UNITED STATES PATENT AND TRADEMARK OFFICE

APPLICATION NO.	FILING DATE	FIRST NAMED INVENTOR	ATTORNEY DOCKET NO.	CONFIRMATION NO.
10/775,943	02/10/2004	Jeremy B. Ross	159803/FLU002	3179
23444	7590	12/29/2005	EXAMINER	
ANDREWS & KURTH, L.L.P. 600 TRAVIS, SUITE 4200 HOUSTON, TX 77002			LEE, GUNYOUNG T	
			ART UNIT	PAPER NUMBER
			2875

DETAILED ACTION

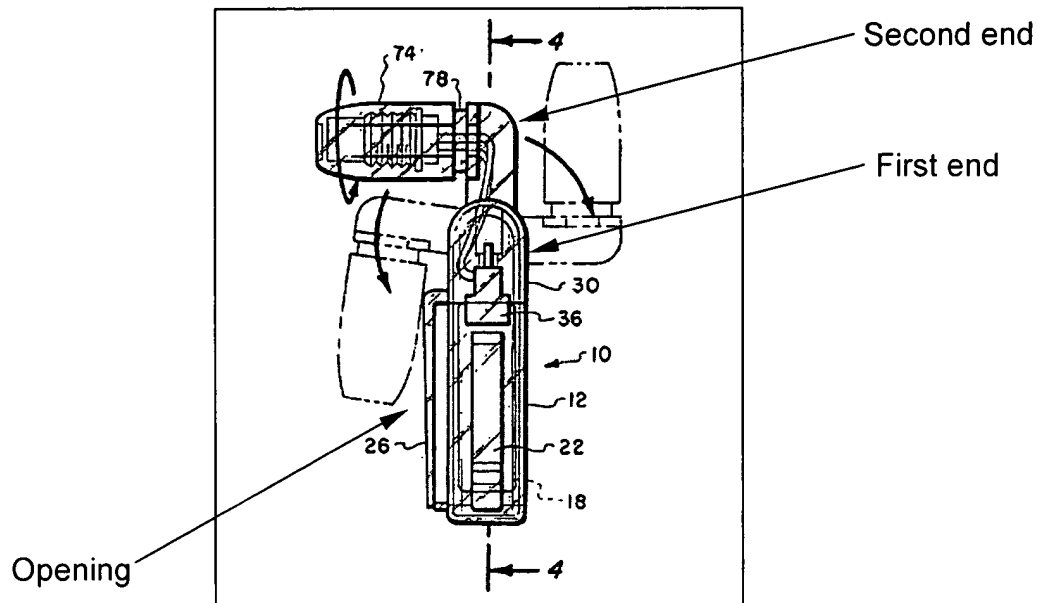
9. In regards to claims 1, 3-9 and 13-16, Parker discloses a versatile-use flashlight having:

- A rotatable handle portion (Fig. 2, 12);
- A first member (Fig. 3, 54) having a first end and a second end, the first end connected to the handle portion (12) (as shown in the picture on page 4);
- A rotatable lightbox (Fig. 2, 74) connected to the said second end;
- Wherein the lightbox (Fig. 2, 74) is movable relative to the handle portion (12);
- An opening defined between the handle portion (Fig. 2, 12), the first member (54), and the lightbox (74) (as shown in the picture on page 4);
- Wherein the handle portion (Fig. 2, 12), the first member (54), and the lightbox (74) form a substantially U-shaped configuration.
